RED BANK OUTLINE PLANNING APPLICATION, AND NT02-04 NEW TOWN FULL PLANNING APPLICATION

Environmental Statement Volume 4: ES Addendum

July 2023

Far East
Consortium

Figure 3: Traffic Regulation Order in Red Bank and Dantzic Street

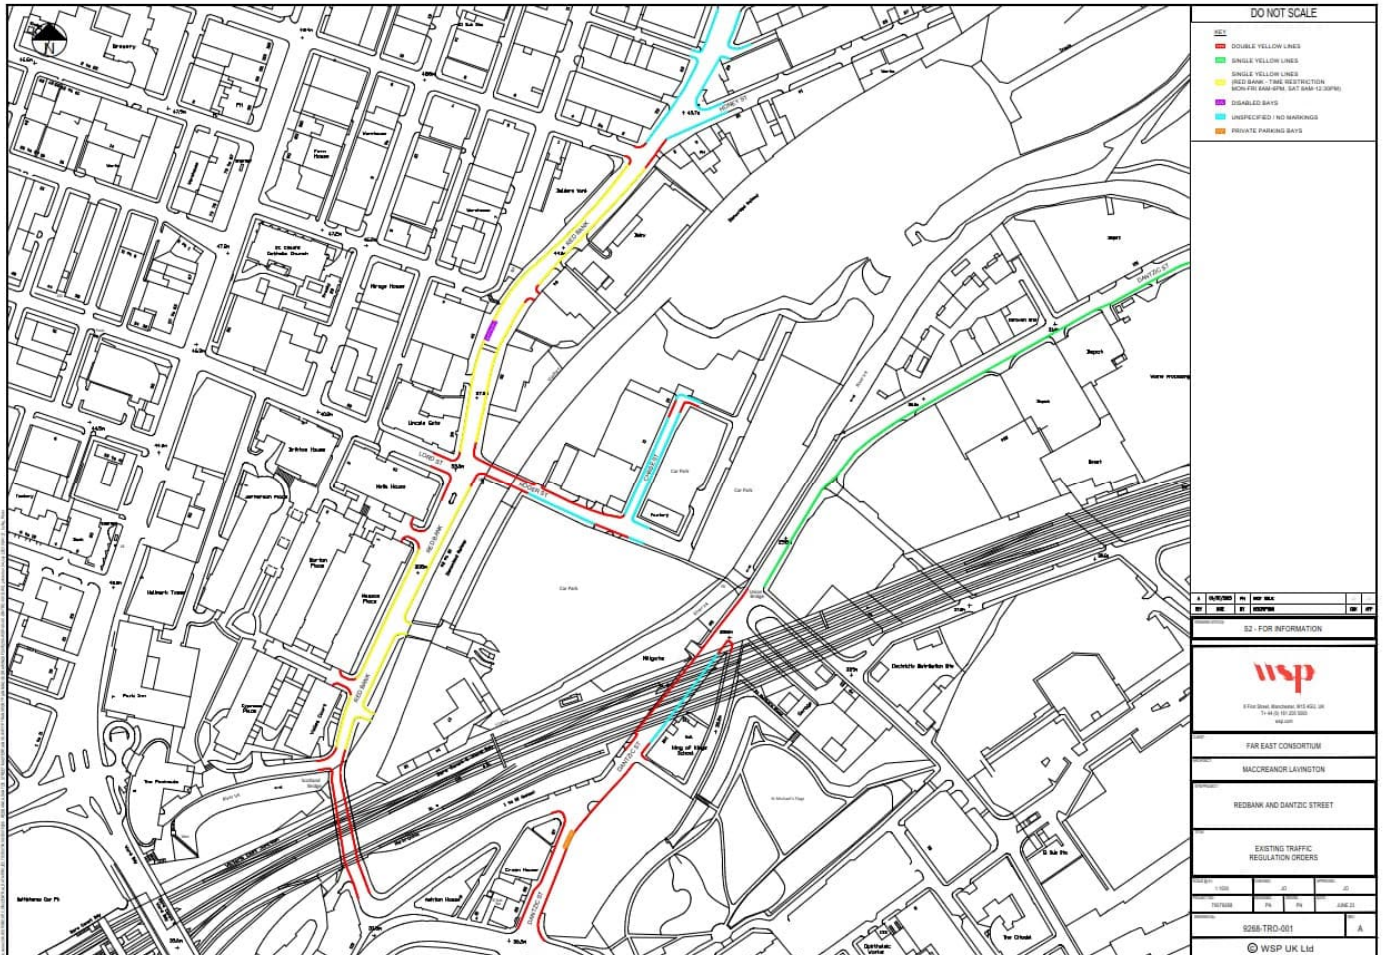
The existing Traffic Regulation Orders in the vicinity of Redbank and Dantzic Street development are shown in Figure 3 and Figure 4.

The details of proposed TROs would be agreed in parallel with the Section 278 process, however as a general principle it is proposed that a no parking TRO would be implemented along the section of Dantzic Street adjacent to plots NT02-04, to ensure safe and efficient passage of both cyclists and vehicles (including buses) along the Dantzic Street carriageway.

Figure 5: Bus Stop 5-Minute Catchment Area

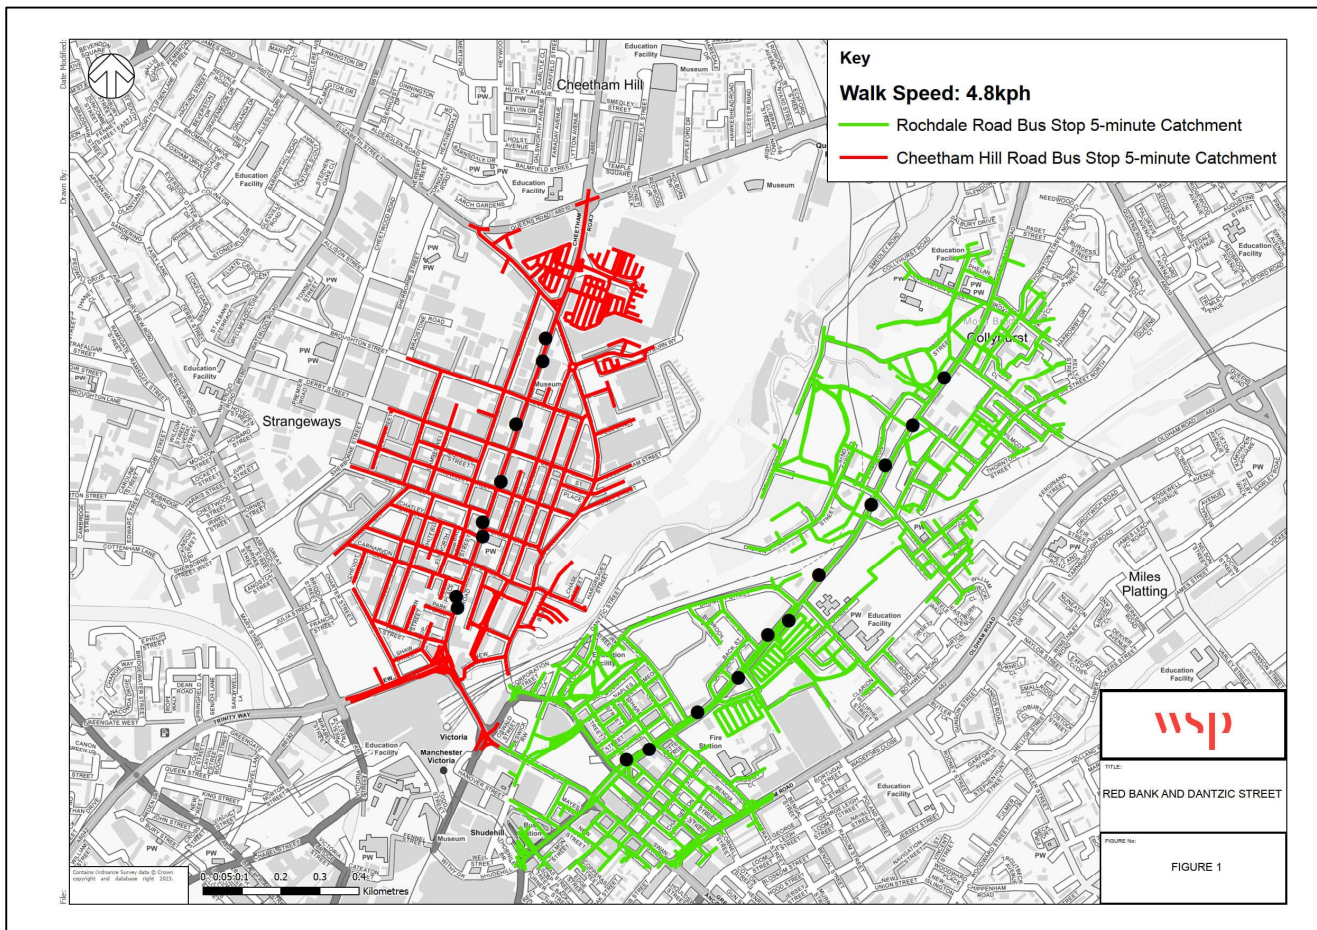
As requested a 5 minute bus stop catchment plan from stops on Rochdale Road and Cheetham Hill Road is included in Figure 5 below. This demonstrates that sections of the site will fall within a 5 minute walk even without diversion of buses onto Dantzic Street. All of the site would be likely to fall well within a 10 minute catchment from existing bus stops.

- 4.20 As requested by TfGM a 5 minute bus stop catchment plan from stops on Rochdale Road and Cheetham Hill Road is included in Figure 5 in Appendix 2 to this ES Addendum. This demonstrates that sections of the site will fall within a 5 minute walk even without diversion of buses onto Dantzic Street. All of the Application 4 and Application 5 would be likely to fall well within a 10 minute catchment from existing bus stops. In the event that bus services are diverted onto Dantzic Street, bus stops would be provided on-street, and this would further reduce the walk distance from Application 4 and Application 5 to public transport services. This does not alter the assessment of impacts or the mitigation measures identified in the April 2023 ES.

RDB-WSP-XX-XX-DR-TP-026

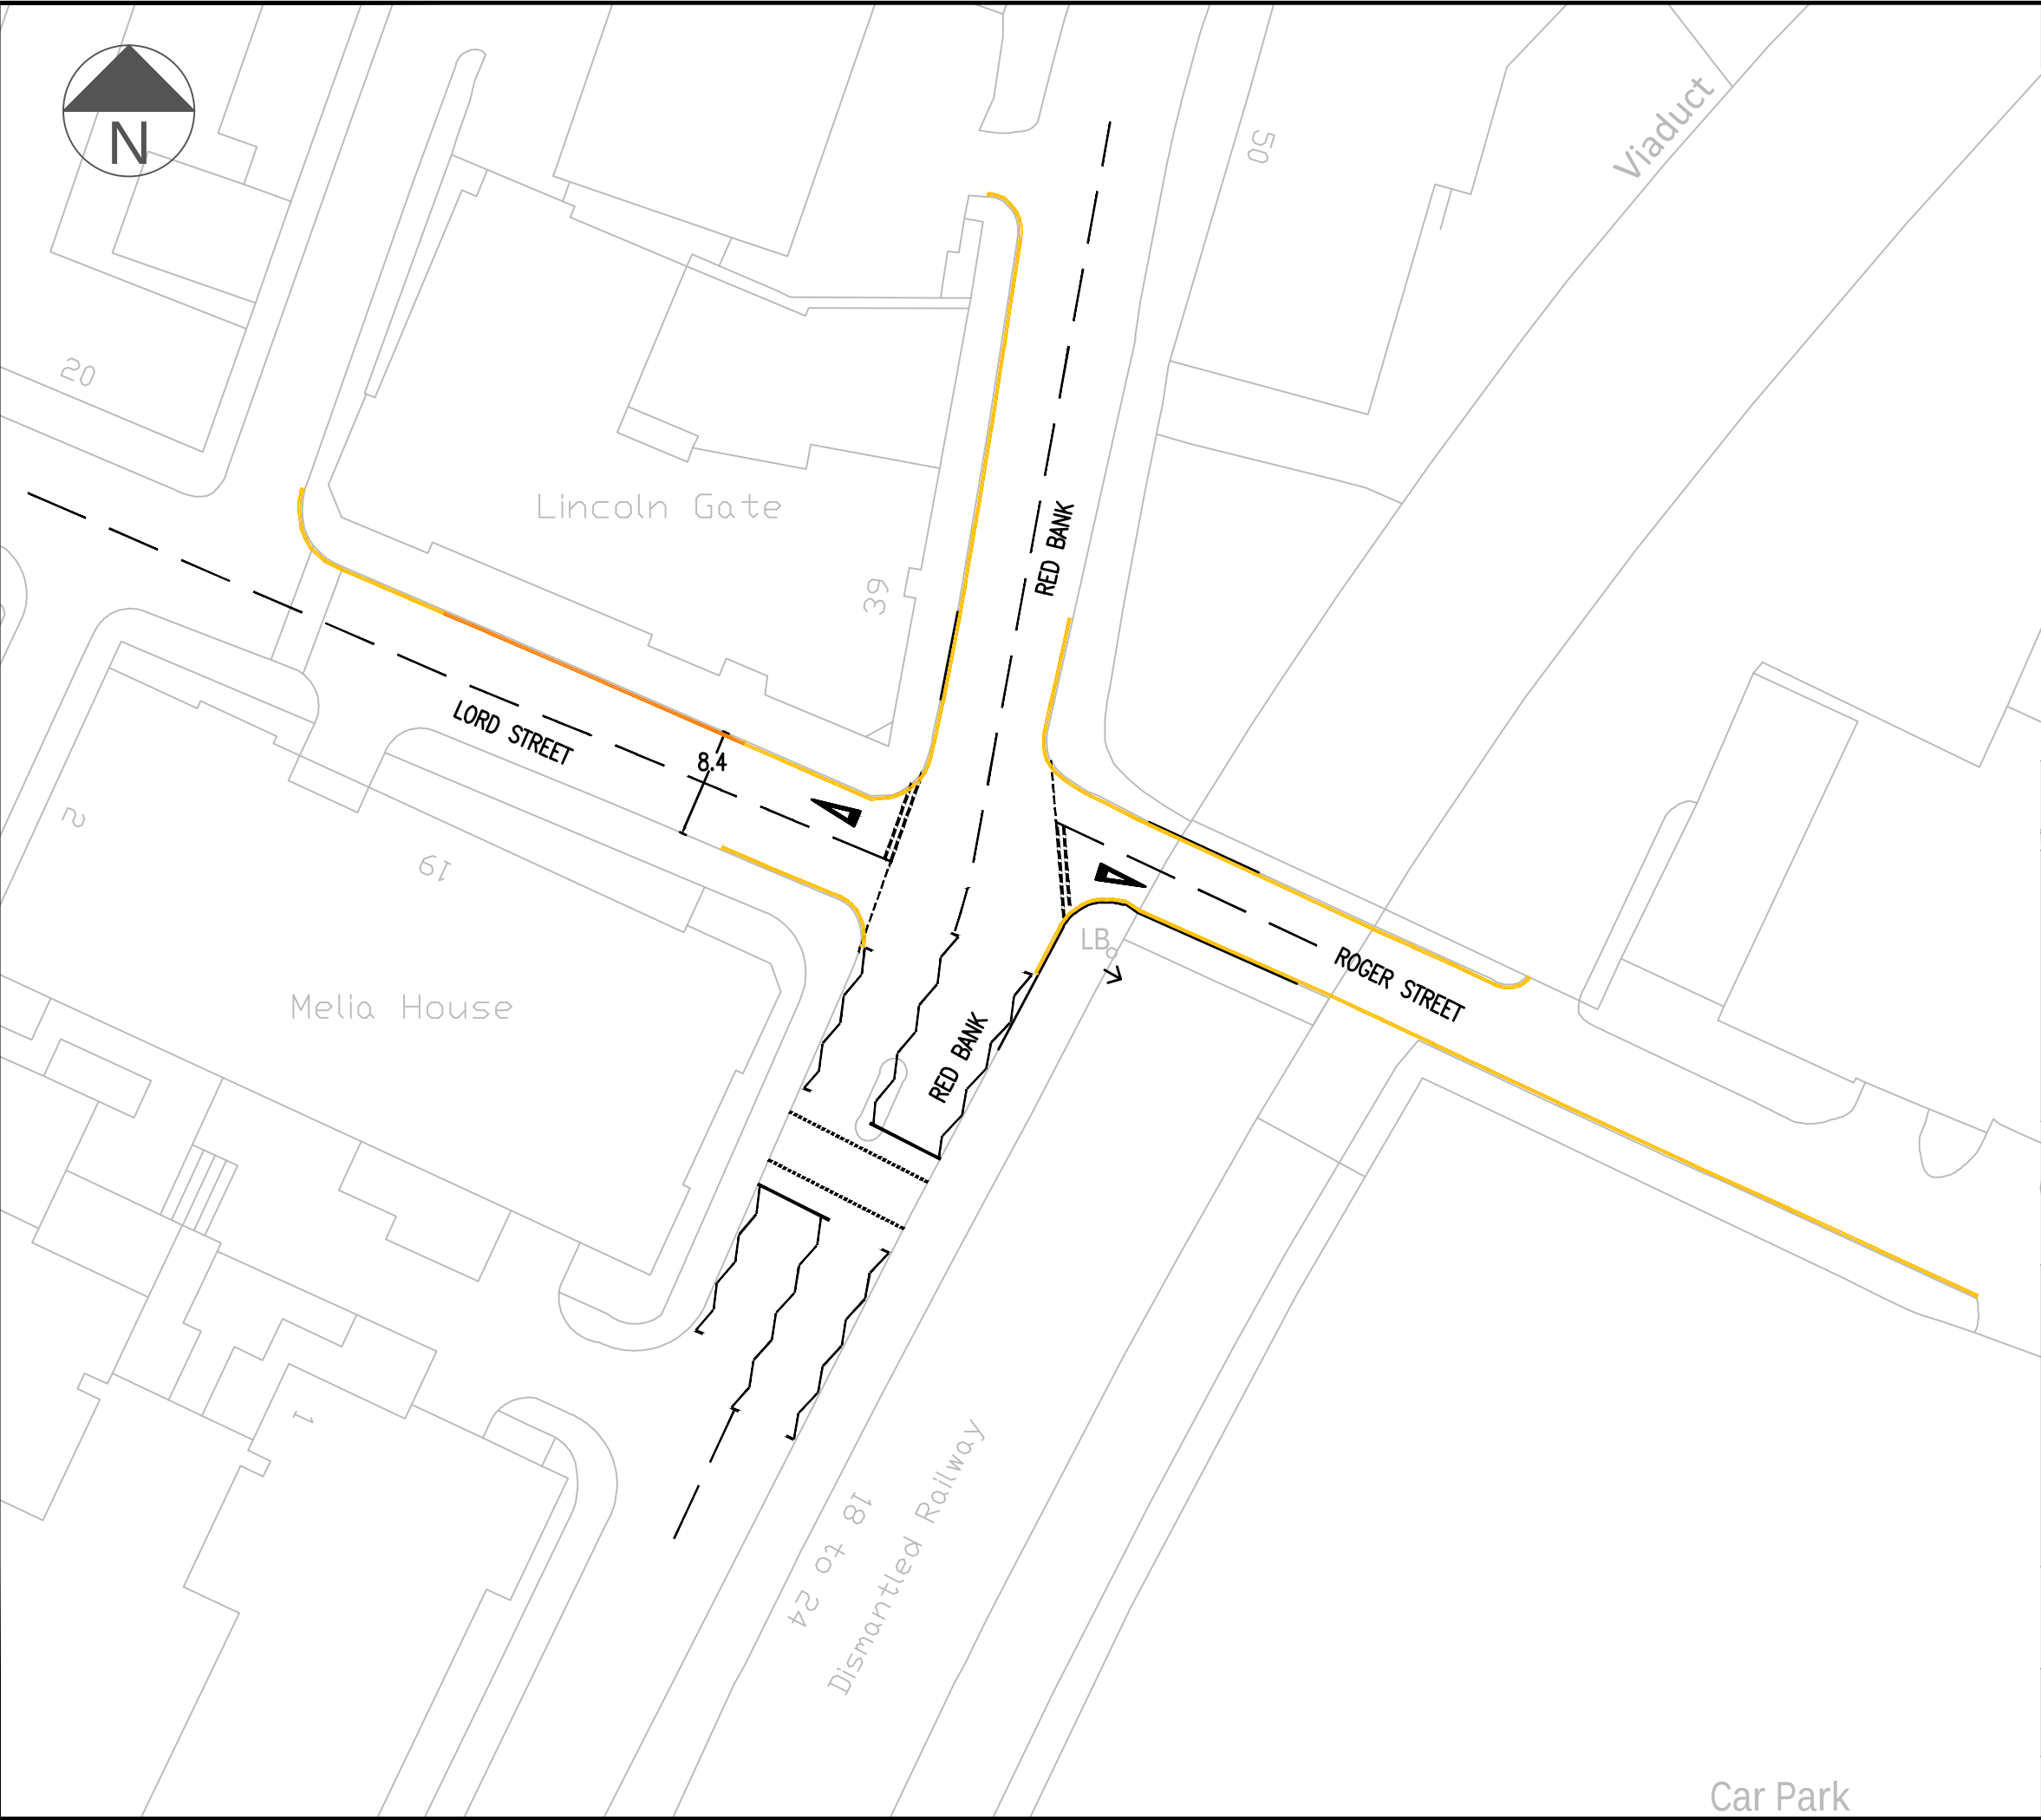
- 4.29 The vehicle carriageway width along Dantzic Street adjacent to plots NT02-04 has been widened to 6.5m in line with the request from TfGM. This amended design is shown in drawing RDB-WSP-XX-XX-DR-TP-018 rev P03 included in Appendix 2 to this ES Addendum. To achieve this, the width of the footway south of Dantzic Street has been reduced though its width remains above 3.0m at all points. This replacement drawing relates to Application 5 and has consequential changes for Chapter 5 Proposed Development- paragraph 5.34 and the Non Technical summary- Paragraph 5.30 of the April 2023 ES where reference to 6.2m is replaced with 6.5m. These changes do not change the assessment of effects reported in the April 2023 ES.

A 1:500 drawing of the Dantzic Street highway improvements is included in this note as drawing RDB-WSP-XX-XX-DR-TP-026 rev P01. The revised mitigation scheme at Redbank / Roger Street / Lord Street is included in this note as 70079268-WSP-XX-XX-DR-TP-022 rev P02
